FINAL PLAT

AUBURN HILLS ADDITION

Re: S/D 94-12 - AUBURN HILLS ADDITION (Final Plat)

CASE NUMBER: S/D 94-12 AUBURN HILLS [Previously CANNONBALL ADDITION (135th & Maple)]

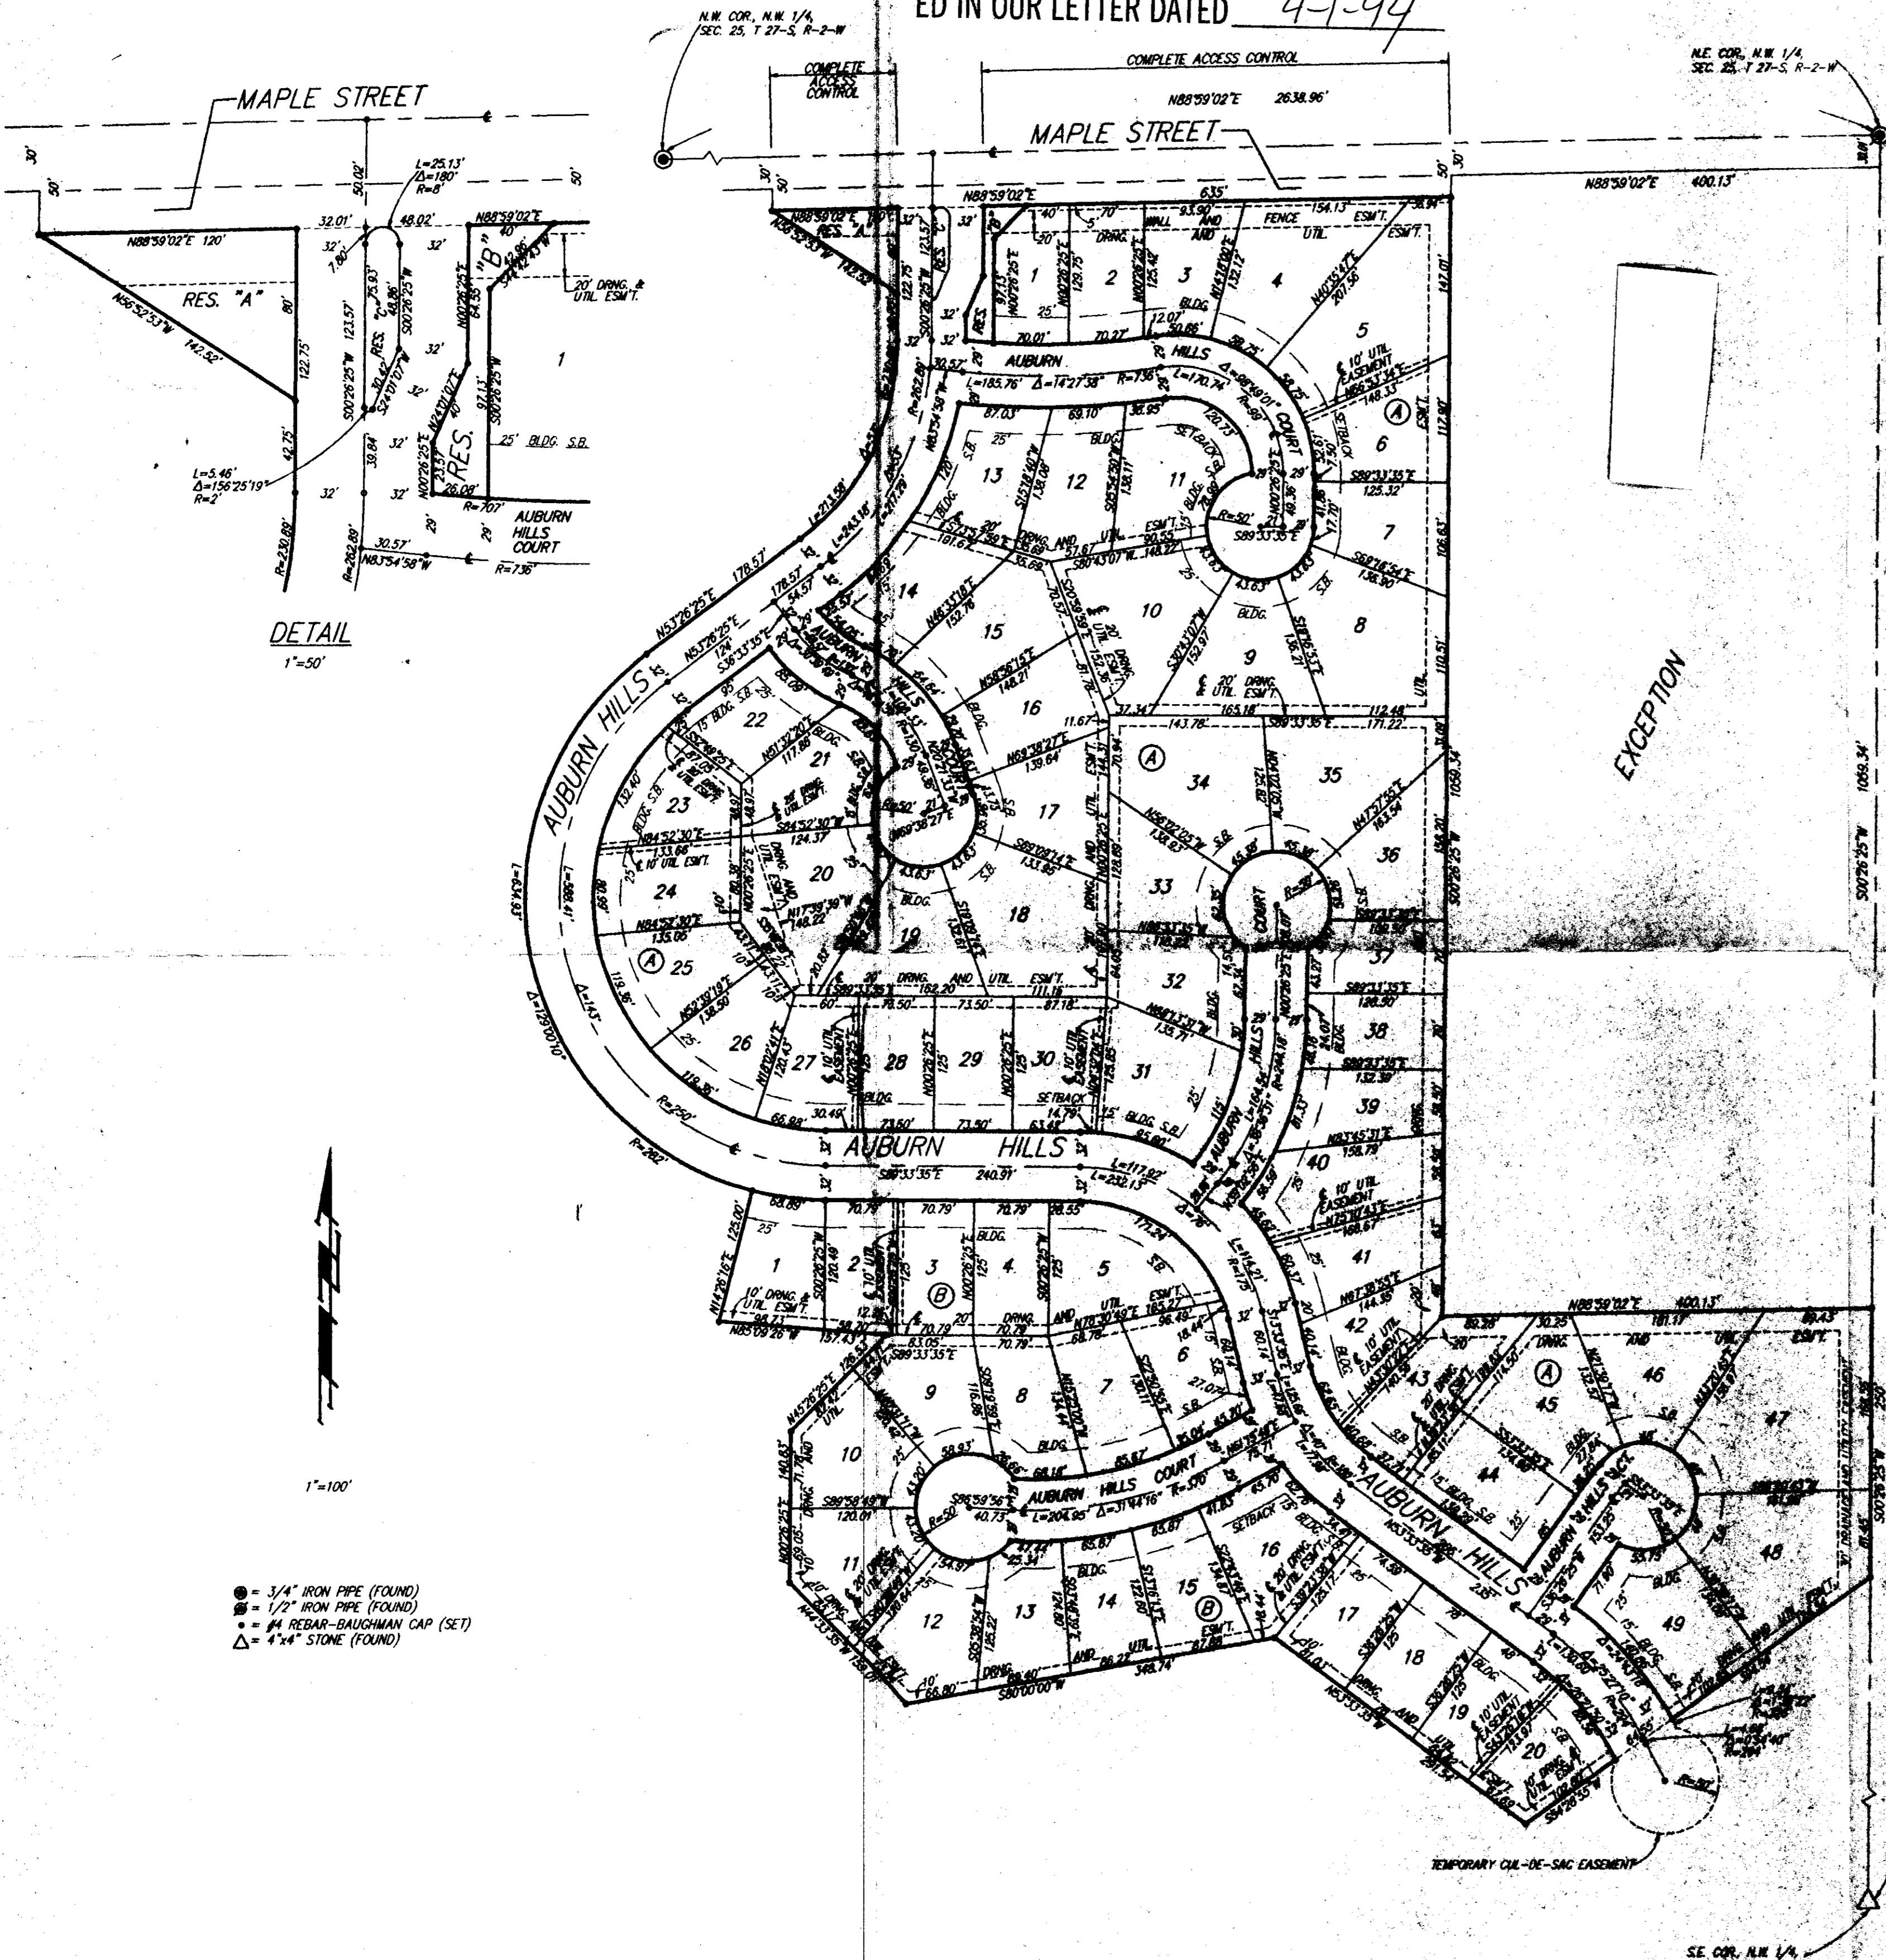
- T. Recording of the plat within 30 days after approval by the City Council.**
- U. As requested by City Engineering, the applicant shall submit, by separate instrument, needed off-site drainage and utility easements. These easements need to be submitted to Engineering for review and approval and subsequently to Planning with the plat, for recording.**

Also, as indicated by City Engineering, minimum building pad elevations shall be dedicated for all lots adjacent to an open space area containing lakes and/or detention ponds. It shall be noted if the elevation is for the lowest opening or floor elevation and both on-site and off-site benchmarks shall be referenced.

- A. Prior to this plat being scheduled for City Council review, this site will need to be annexed to the City. Annexation is required in order to plat the size of lots being indicated by this plat. Although this portion of the quarter section does abut the present City Limits at its eastern most property line and can therefore be annexed by itself, it is recommended that the applicant(s) submit an annexation request for the entire quarter section.

- B. The applicant shall guarantee the extension of sanitary sewer to serve the lots being platted.
- C. The applicant shall guarantee the extension of City water to serve the lots being platted.

- D. The applicant shall guarantee any drainage improvements required by the platting of this property.
- E. The applicant shall guarantee construction of the storm sewers required by this plat.

- F. The applicant shall guarantee the paving of the proposed interior streets.
- G. The above paving petition shall also provide for sidewalks along one side of Auburn Hills. Based upon the overall sketch plat, some portions of sidewalks could be considered, as an alternative, being located in an open space/drainage corridor that crosses this site from west to east. At this time the applicant shall guarantee sidewalk adjacent to the street up to the vicinity of Lot 1, Block B. Based upon the applicant's overall plans for this area and indicated agreement, an equivalent segment of sidewalk may be placed in the open space reserve to be platted south of this site rather than along the remaining portion of Auburn Hills.

- H. In terms of the overall development planned for this quarter section, 135th Street West can be expected to be a major means of access to both the residential development and if a 16 acre area of "LC" zoning is obtained, even more so for these uses. As an unpaved street consequently, paving is going to be needed for this street south from Maple. This plat and all subsequent plats in this quarter section need to therefore guarantee their participation in future paving of 135th Street that is proportionate to the traffic impact created by this development.

Therefore, before submitting the final plat tracing for City Council review, the applicant shall meet with Planning and City Engineering in order to determine an appropriate guarantee from this site for the paving of 135th Street West.

developed. Only one entrance, as shown on this plat, and two off of 135th Street West will be used for access. These improvements need to be considered not only in light of the anticipated number of residential lots but also the potential "LC" zoning being proposed. As indicated by Traffic Engineering, a guarantee shall be provided for left-turn improvements in Maple to serve this site's entrance at Maple. This guarantee will be held until traffic levels and planned improvements to Maple warrant this improvement.

- J. Provisions shall be made for ownership and maintenance of the proposed reserves. The applicant shall either form a lot owners' association prior to recording the plat or shall submit a covenant stating when the association will be formed, when the reserves will be deeded to the association and who is to own and maintain the reserves prior to the association taking over those responsibilities. This covenant shall provide that the homeowners' association will maintain the open space area or "parking strip" located between this plat's north line and the paved surface of Maple.

- K. The applicant shall submit a covenant which provides for four (4) off-street parking spaces per dwelling unit on each lot which abuts a 58-foot street. The covenant shall inventory the affected lots by lot and block number and shall state that the covenant runs with the land and is binding on future owners and assigns.

- L. As requested by the representative from the City's Fire Department, the street names on this plat shall be changed to reflect the use of the existing street name Limuel.

- M. The platting binder presently indicates that this site is owned by another party or not as is indicated on this final plat. Before the plat will be released for recording, proof of ownership shall be shown for the party indicated on the final plat.

- N. The applicant shall install or guarantee the installation of all utilities and facilities which are applicable and described in Article 8 of the MAPC Subdivision Regulations.

- R. The applicant needs to determine with Engineering the nature or extent of any detailed drainage study needed for the overall quarter section in which this plat is located.

- S. Perimeter closure computations shall be submitted with the final plat tracing. Section
